[Docket No. FAA-2023-0921; Project Identifier AD-2022-01430-T]

Airworthiness Directives; The Boeing Company Airplanes

ACTION: Notice of proposed rulemaking (NPRM).

SUMMARY: The FAA proposes to supersede Airworthiness Directive (AD) 2022-05-04, which applies to all The Boeing Company Model 737-100, -200, -200C, -300, -400, -500, -600, -700, -700C, -800, -900, and -900ER series airplanes, except for Model 737-200 and -200C series airplanes equipped with a certain flight control system.

Figure 1 to paragraph (g)(2)(i) – *Fundamental Effective Isotropic PSD at Outside Interface of Aircraft Antenna*

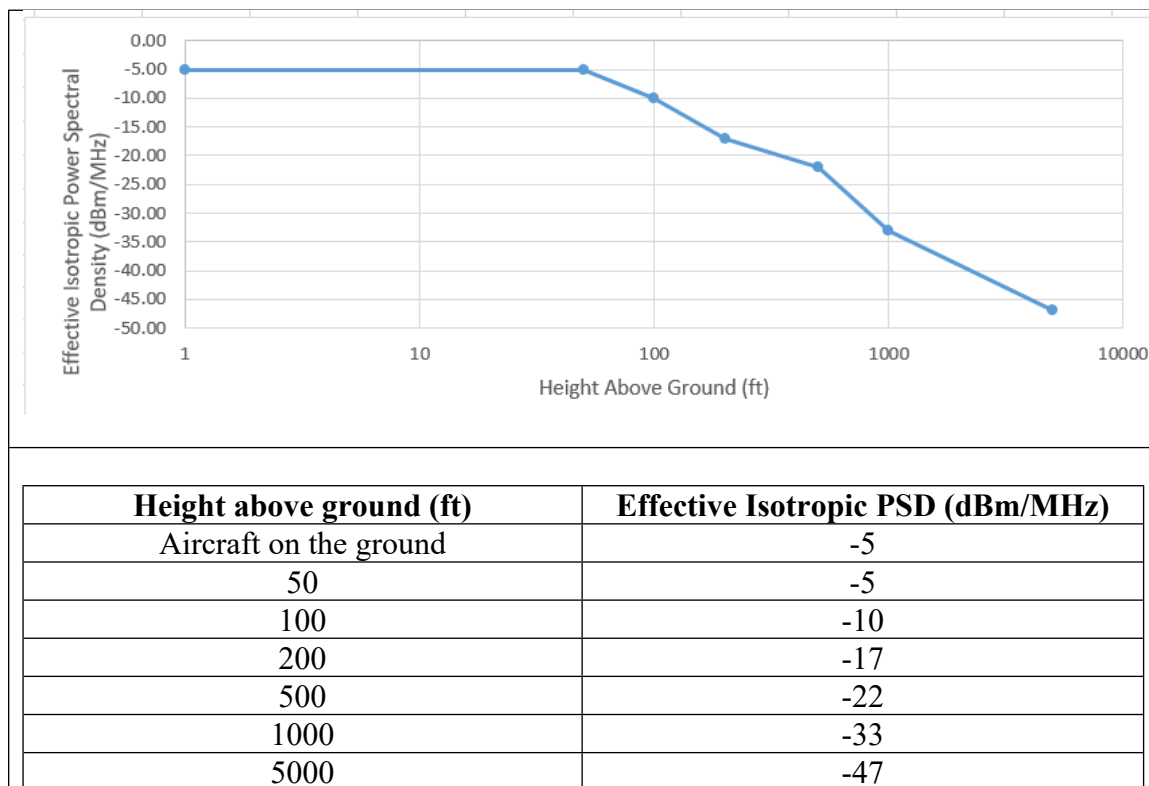
(i) Tolerance to radio altimeter interference, for the fundamental emissions (3.7-3.98 GHz), at or above the power spectral density (PSD) curve threshold specified in figure 1 to paragraph (g)(2)(i) of this AD.

Figure 2 to paragraph (g)(2)(ii) – Spurious Effective Isotropic PSD at Outside Interface of Aircraft Antenna

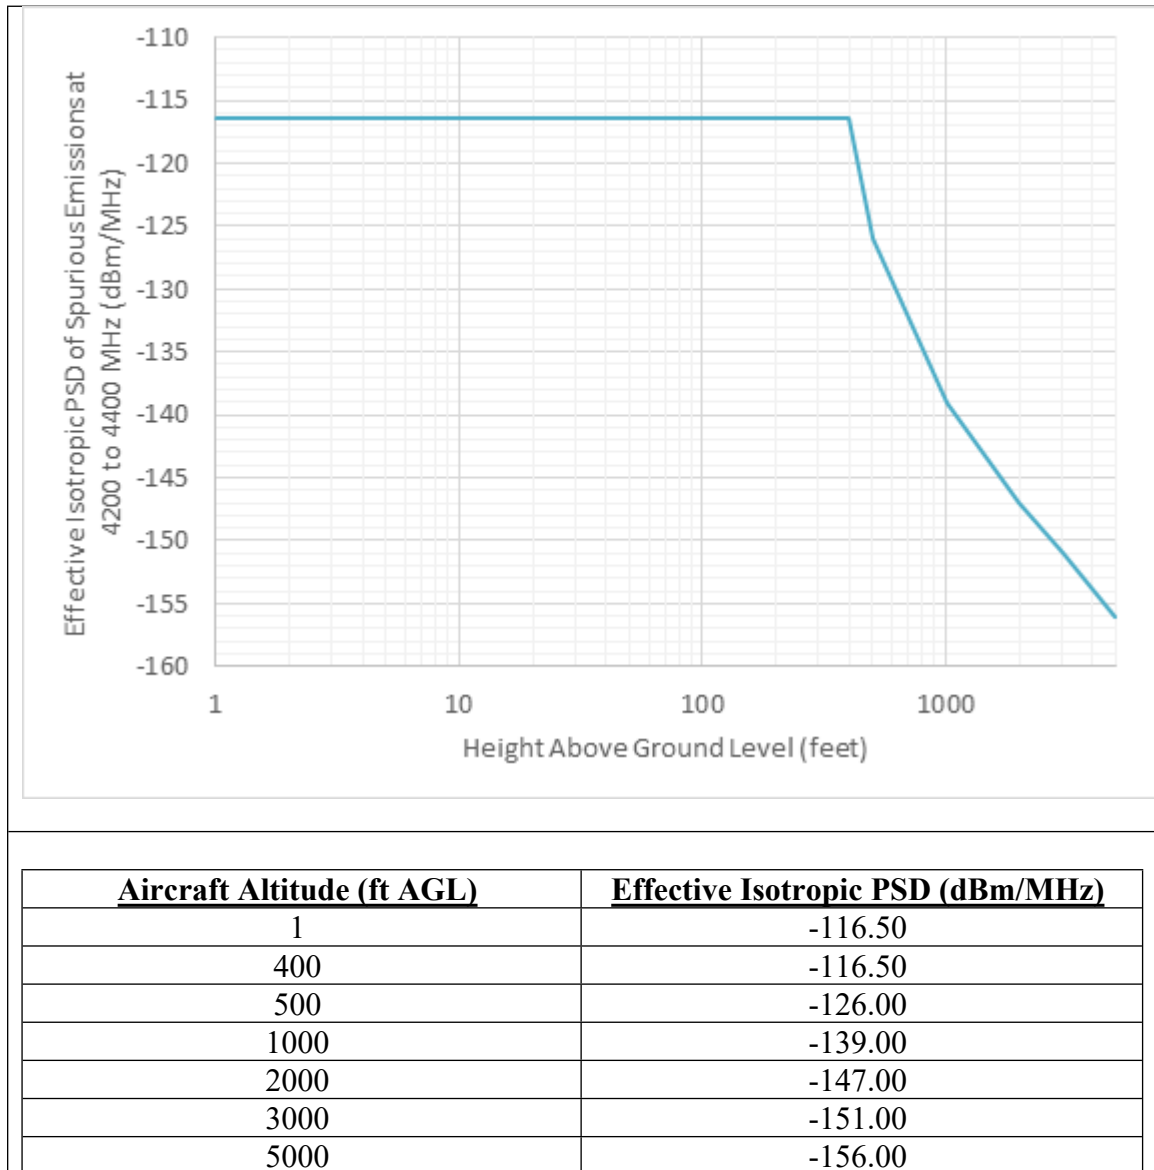
(ii) Tolerance to radio altimeter interference, for the spurious emissions (4.2-4.4 GHz), at or above the PSD curve threshold specified in figure 2 to paragraph (g)(2)(ii) of this AD.
